PUSD MARTIN LUTHER KING JR JUNIOR HIGH SCHOOL RUNNING TRACK AND FIELD ALTERATIONS

BID ADDENDUM NO. 3 November 19, 2025

PROJECT: Martin Luther King Jr Junior High School Running Track & Field Alterations

REFERENCE DRAWING:C2.01

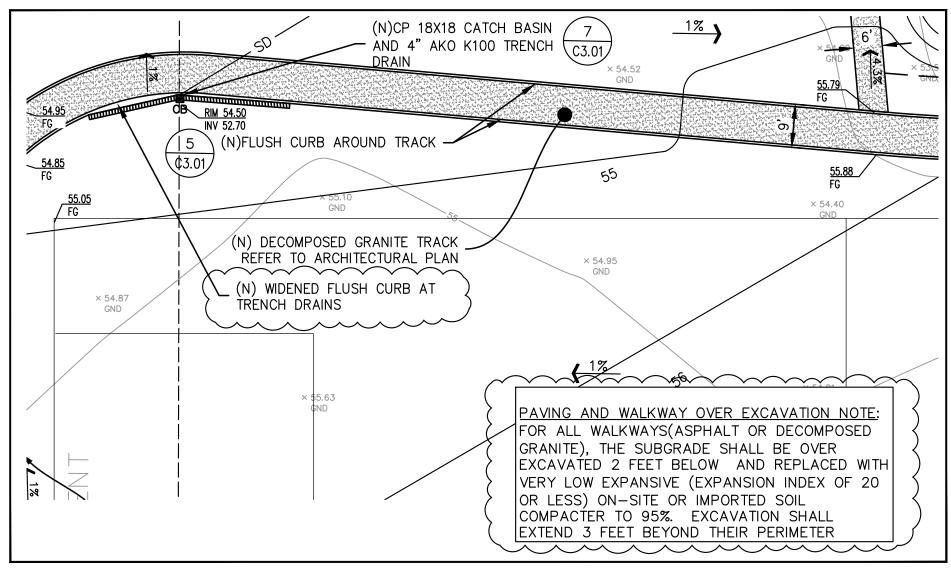
Description: Revise Keynote 01 to read as follows "CONTRACTOR SHALL

CLEAR AND GRUB THE TURF AREA, REMOVE TOP 8" OF SOIL AND REMOVE IRRIGATION PER IRRIGATION DRAWINGS.
CONTRACTOR SHALL REFER TO ATTACHED TOPOGRAPHICAL SURVEY FOR EXISTING GRADES AND THEN USE CIVIL C2.01

"PAVING AND GRADING PLAN" THAT SHOWS ALL NEW

REFERENCE DRAWING: A1.02

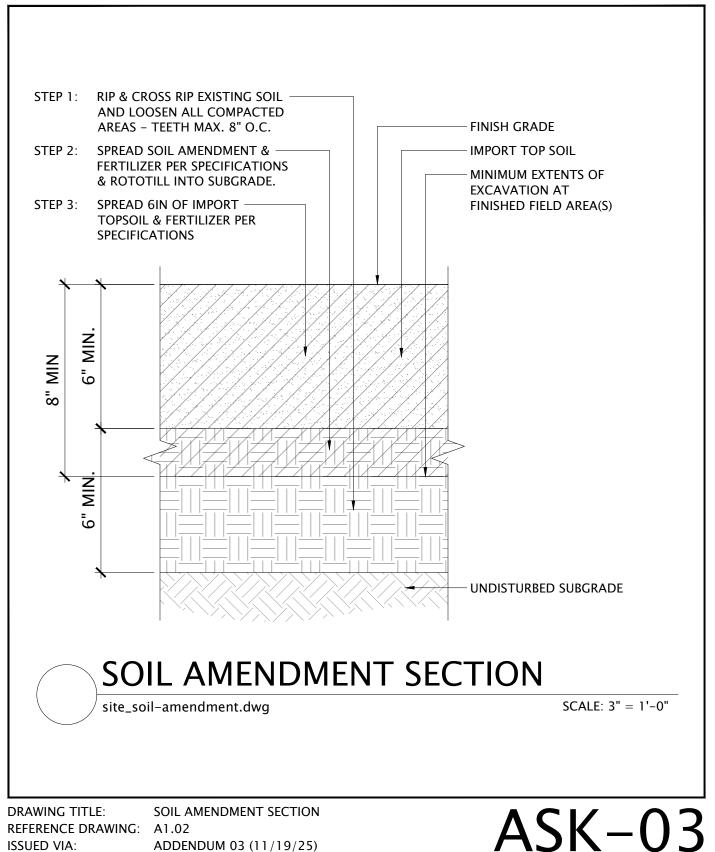
Description: Add demolition Keynote 10 to Keynotes to read as follows
